## WOODLANDS OF CHARMINGDALE SUBDIVISION

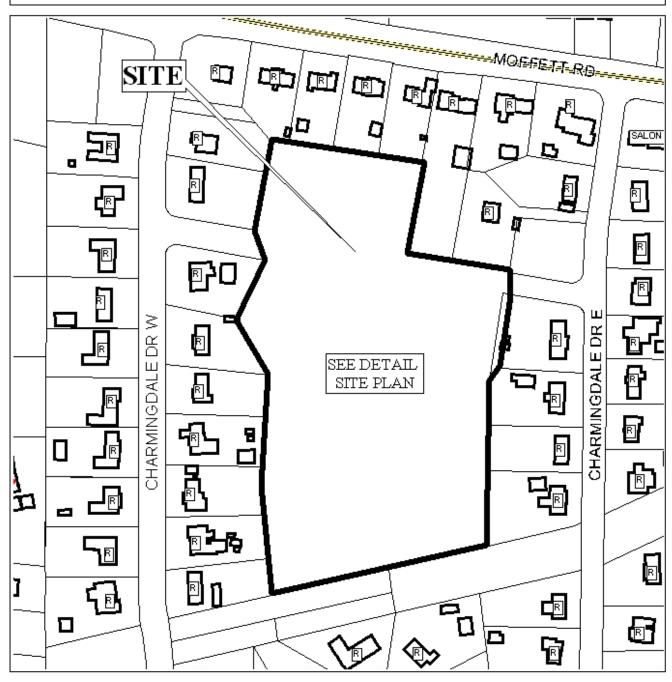
<u>Engineering Comments:</u> Must comply with the Mobile County Flood Damage Prevention Ordinance.

The site fronts onto street stubs for Charmingdale Court North and unopened, unnamed public right-of-way on the East side of Charmingdale Drive West. Both streets are minor streets. Each street lacks curb-and-gutter, thus the 50-foot right-of-way is less than the minimum required 60-foot width. The applicant proposes news roads within the subdivision that will have a 50-foot right-of-way.

A detention basin is proposed for the subdivision near the unopened street-stub on the West side of the site. Review of contour information, which should be depicted on the plat, indicates that the proposed location is at the lowest point within the site. The plat should be revised to depict contours, as required in Section IV.2.b. of the Subdivision Regulations, and a note should be placed on the final plat, if approved, stating that maintenance of the detention basin common area, and any other common areas, is the responsibility of the subdivision's property owners.

While the site is in the County, the applicant's engineer will be required to certify that the stormwater detention, drainage facilities, and release rate comply with the City of Mobile stormwater and flood control ordinances, prior to the signing and recording of the final plat, if approved.

This site is located in Mobile County, thus a note should be placed on the Final Plat stating that any lots which are developed commercially and adjoin residentially developed property must provide a buffer, in compliance with Section V.A.7. of the Subdivision Regulations.

Based upon the preceding, the application is recommended for Tentative Approval, subject to the following conditions: 1) revision of the plat to depict the contour information required by the Subdivision Regulations; 2) labeling of all common areas, and placement of a note on the plat stating that maintenance of the detention basin common area, and any other common areas, is the responsibility of the subdivision's property owners; 3) provision of a certification letter from a licensed engineer to the Planning Section of Urban Development, certifying that the stormwater detention, drainage facilities, and release rate comply with the City of Mobile stormwater and flood control ordinances, prior to the signing and recording of the final plat; 4) revision of the plat to label each lot in square feet, or provision of a table on the plat depicting the same information; and 5) placement of a note on the plat stating that any lots which are developed commercially and adjoin residentially developed property must provide a buffer, in compliance with Section V.A.7. of the Subdivision Regulations.
